**RE: Austin-Bergstrom International Airport - Environmental Assessment  
Floodplain Determination/Finding  
Austin, Texas**

RE: JetStar FBO and Private Hangars  
Emma Browning Avenue  
Austin, Texas 78719

CITY OF AUSTIN – PLANNING AND DEVELOPMENT REVIEW DEPARTMENT  
SITE PLAN APPLICATION – MASTER COMMENT REPORT

PROJECT NAME: **JetStar FBO and Private Hangars (ABIA Project No. F5006.01)**  
LOCATION: **4801 & 4805 EMMA BROWNING AVE**

**Attachment D  
SPONSOR'S PROPOSED ACTION ENCROACHMENT ON 100-YEAR  
FLOODPLAIN**

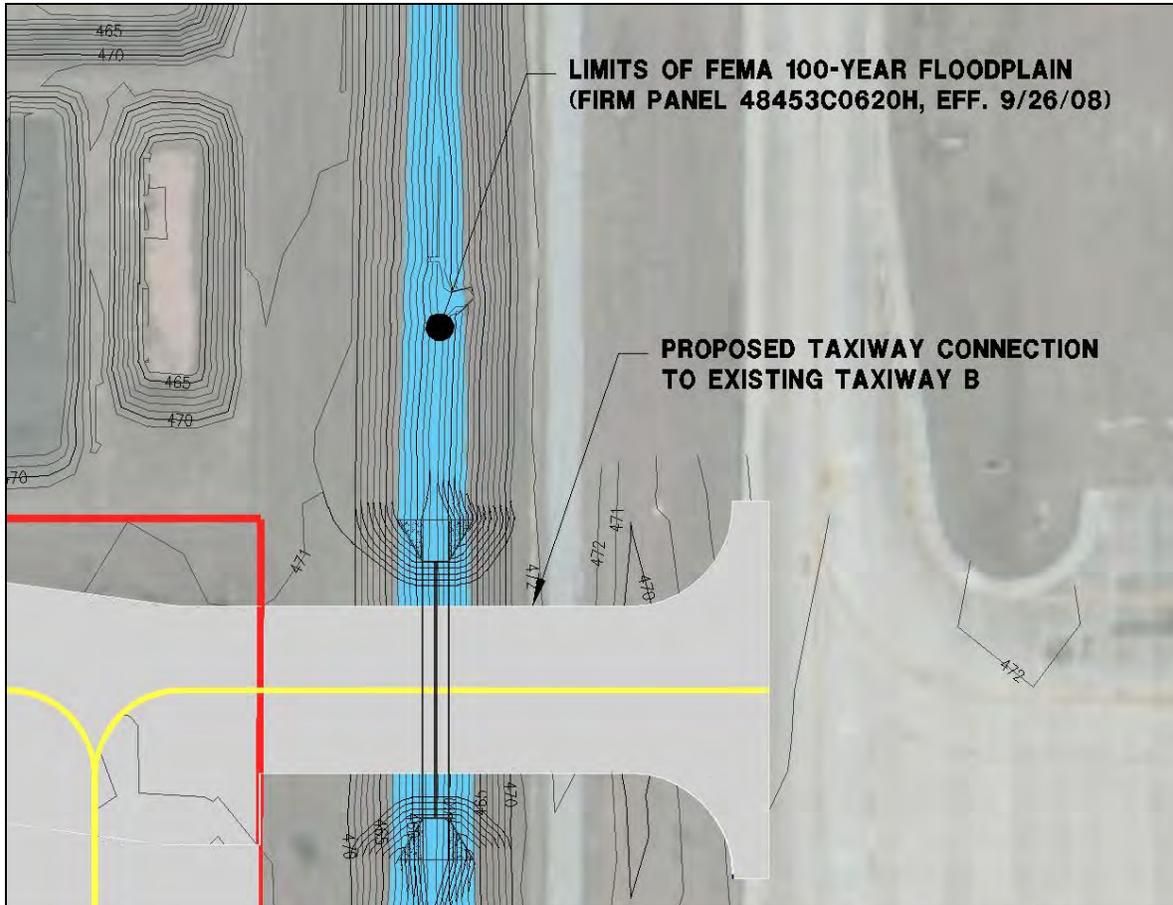
Alternative 2, Connect to Existing Taxiway B (Sponsor's Proposed Action), includes encroachment on a small portion of the FEMA designated 100- year floodplain Zone AE as shown in **Attachment D**.

The flow-line of the existing man-made ditch is approximately 458 feet. The base flood elevation (BFE), as dictated by the Federal Emergency Management Agency (FEMA), reaches an elevation of 464 feet. The banks of the existing man-made ditch containing the floodplain extend to an elevation of 470 feet, which is six feet higher than the BFE and 12 feet higher than the flow-line.

Although the Sponsor's Proposed Action encroaches on the two-dimensional limits of the floodplain there is no practicable alternative as described above. The developer intends to construct two – 8-foot by 7-foot box culverts to maintain capacity of the existing floodway/ditch, and to mitigate any adverse impact to the 100-year floodplain elevation. The flow-line of the proposed culverts would be at approximately 458 feet above mean sea level (MSL), with an inside-top elevation of 465 feet above MSL (i.e., one foot higher than the BFE). The developer used the HY-8 Culvert Modeler software to size the box culverts in an effort to maintain the existing floodplain capacity. Additionally, the ditch has capacity to hold significantly more volume than necessary for the 100-year-storm. Therefore, the Sponsor's Proposed Action would have little to no adverse effect on the existing BFE, and would not cause negative impacts upstream of the crossing.
